HARTZELL PROPELLER LLC

HC-SL-61-376

Tool Modification and Alternate Propeller Mounting Hardware

May 13, 2026

**Modified Torque Wrench Adapter
Figure 1**

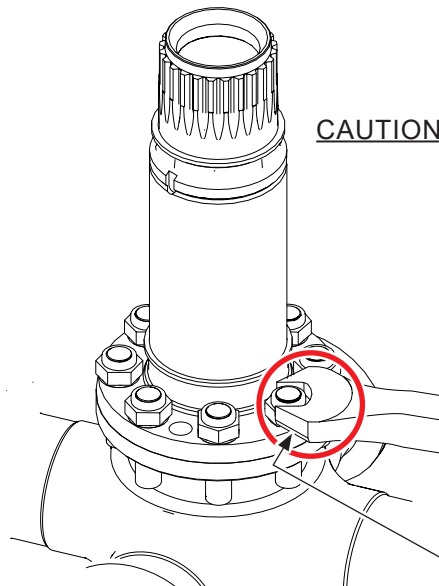
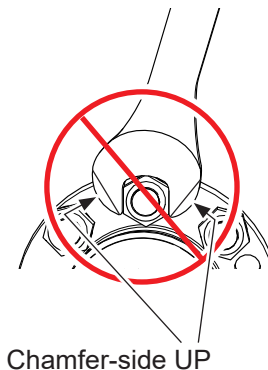
CAUTION 1: DO NOT LET THE TORQUE WRENCH ADAPTER CONTACT THE ADJACENT NUTS OR THE PROPELLER SHAFT FLANGE RADIUS WHEN LOOSENING OR TIGHTENING THE MOUNTING NUTS.

CAUTION 2: ALWAYS USE THE MODIFIED TORQUE WRENCH ADAPTER WITH THE CHAMFER-SIDE DOWN.

Torque Wrench Adapter Modification: Step 1
Figure 2

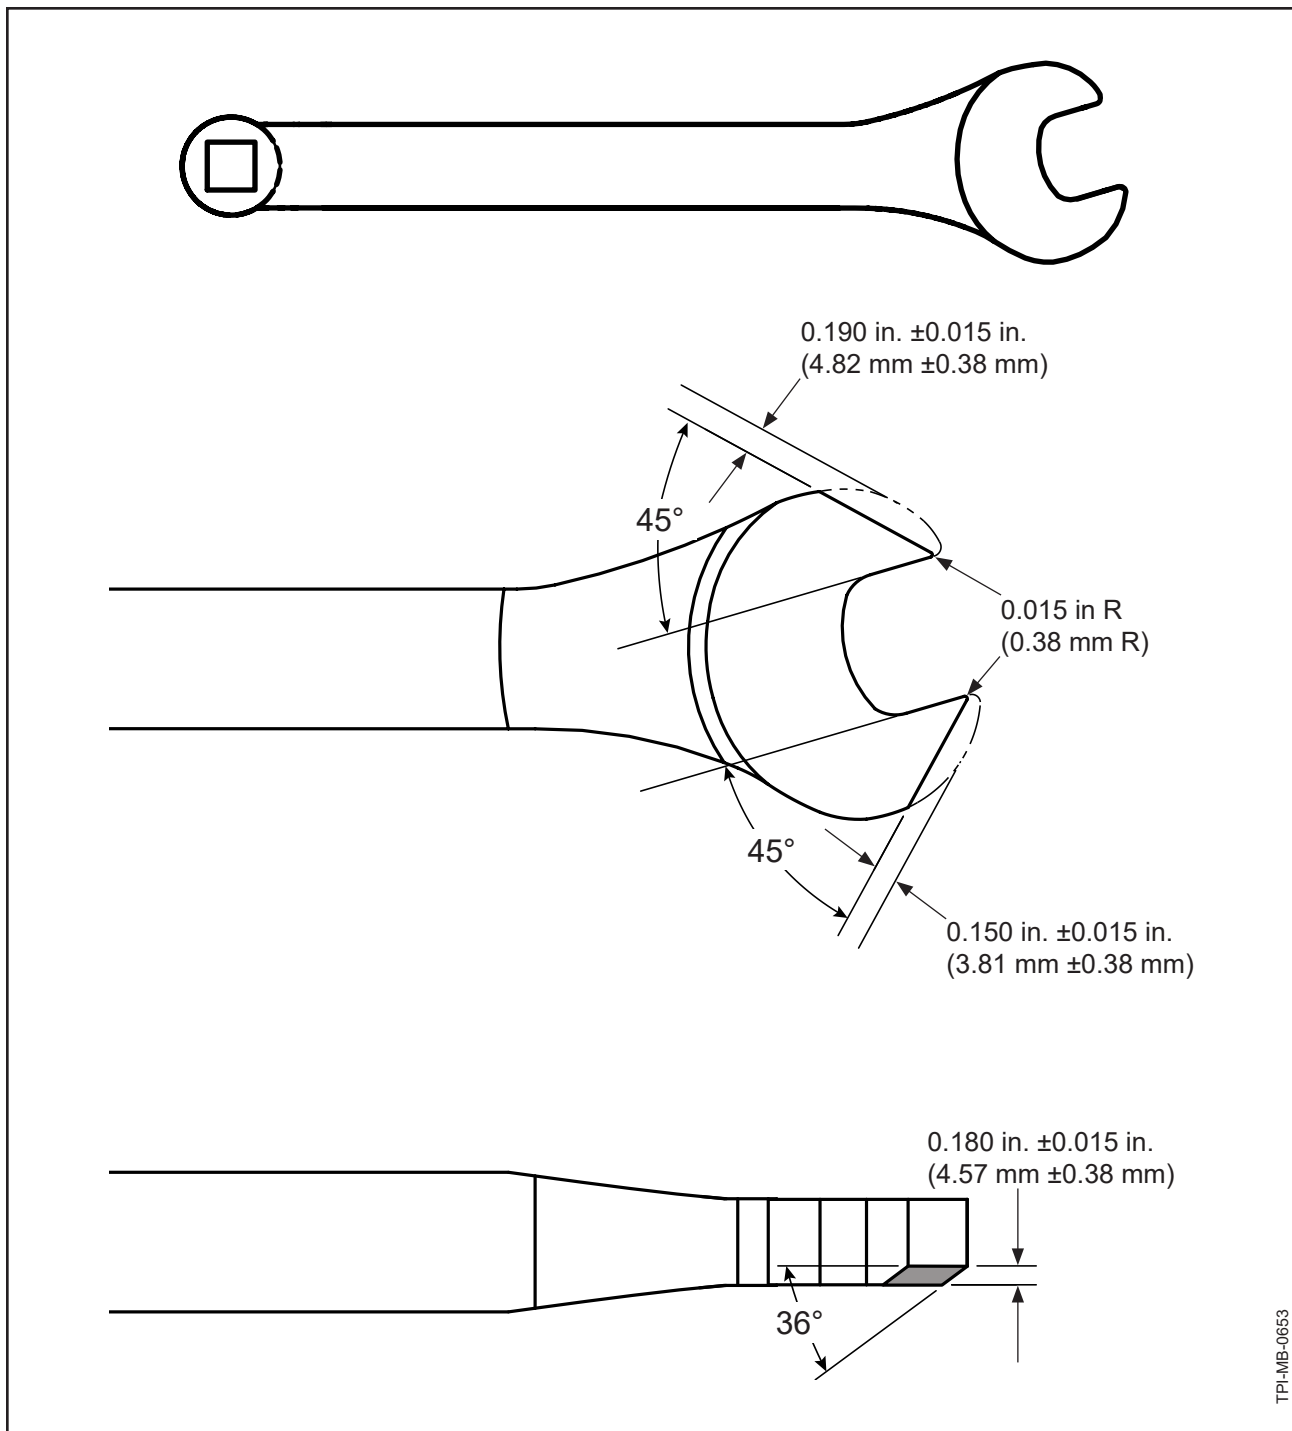
- This revision changes torque wrench adapter TE432 chamfer from 45° to 36°.
- This revision revises Figure 2
- This revision removes Figure 3

- (1) Machine the head of the torque wrench adapter TE432 in accordance with the specifications shown in Figure 2 of this Service Letter.
- (2) Machine 36° chamfers on the bottom sides of the torque wrench adapter TE432 in accordance with the specifications shown in Figure 2 of this Service Letter.
